**DRAINAGE LETTER AMENDMENT  
TO PRELIMINARY/FINAL DRAINAGE REPORT  
FOR AUSTIN BLUFFS PARKWAY  
(MINOR ARTERIAL) FROM WOODMEN ROAD  
NORTH TO MEADOW RIDGE DRIVE**

April 2000

Job No. 8715.70

RE: Drainage Letter Amendment to Preliminary/Final Drainage Report for Austin Bluffs Parkway (Minor Arterial) from Woodmen Road North to Meadow Ridge Drive, as approved in July 1997

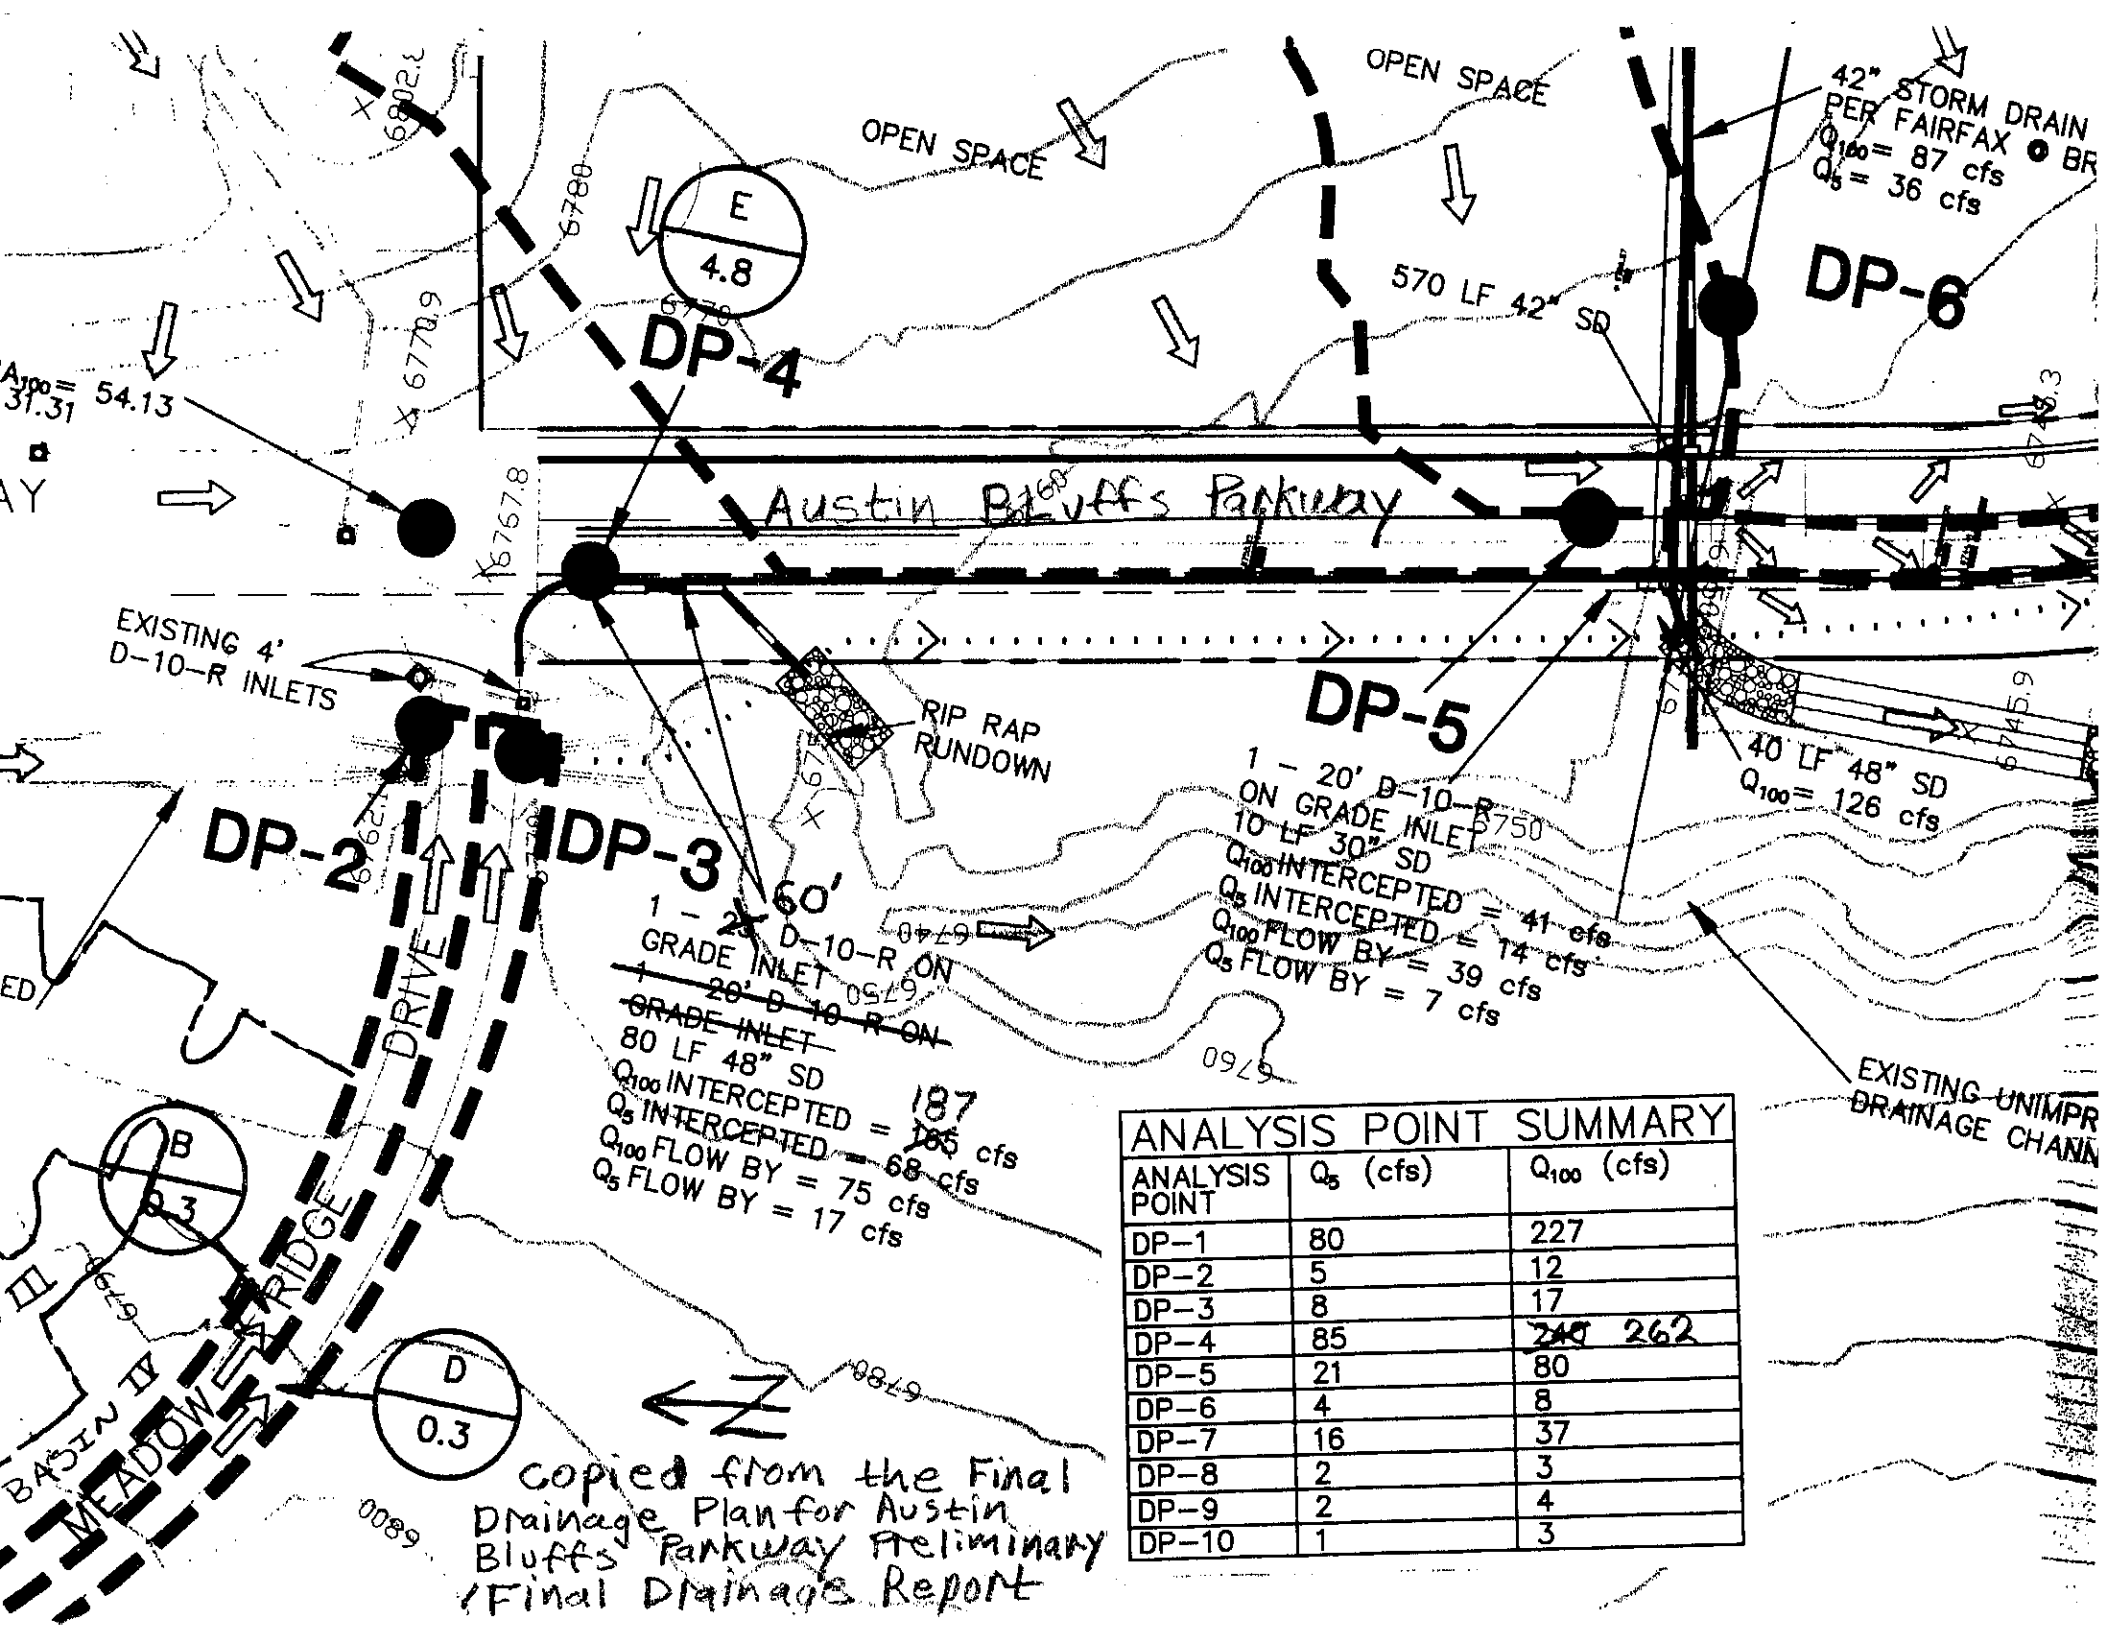
The Austin Bluffs Parkway inlets as previously planned consisted of a 25' long D-10-R and a 20' long D-10-R. The inlets were to be connected by 35 linear feet of 48" diameter RCP. The inlets were proposed to intercept a combined flow of 165cfs in the 100-year design event and allow 75 cfs to flow by. The current proposal is to add 15' of inlet and to combine the separate inlets into one to improve constructability. This will result in a 60' long inlet with an estimated interception capacity of 187 cfs in the 100-year design event. Assuming the additional 22 cfs will result in a 22 cfs increase to the overall 100-year peak flow the lengthened inlet will maintain the same flow by as was proposed in the approve Preliminary/Final Drainage Report for Austin Bluffs Parkway.

The proposed 60' long inlet will be connected to an existing, adjacent 6' x 11' box culvert by an existing 48" diameter RCP. The capacity of the 48" pipe is pushed with the introduction of the additional flow but appears to be adequate (although marginally). The additional flow introduced to the box culvert through the 48" RCP was assumed to already be in the box culvert at this point in previous analysis so it will not negatively affect the overall flow rate in the box culvert.

Calculations to determine inlet capacity are attached. 100-year peak flow depths are estimated at 1.1' above normal flow line elevation at the upstream end of the inlet and 0.7' deep at the downstream end of the inlet. Given that at these depths the inlet opening will be completely submerged and that the 187 cfs flow to be intercepted will be carried within 15' of the curb face, the city standard inlet capacity calculation did not seem appropriate. Instead the orifice equation was used to size the inlet. Capacity based on available head at both ends was determined and an average of these two capacities was used to estimate required length.

The calculations done with this analysis indicate that the proposed revision to the inlet will allow it to intercept the additional flow contributed to Austin Bluffs Parkway by the Antelope Trails Site.
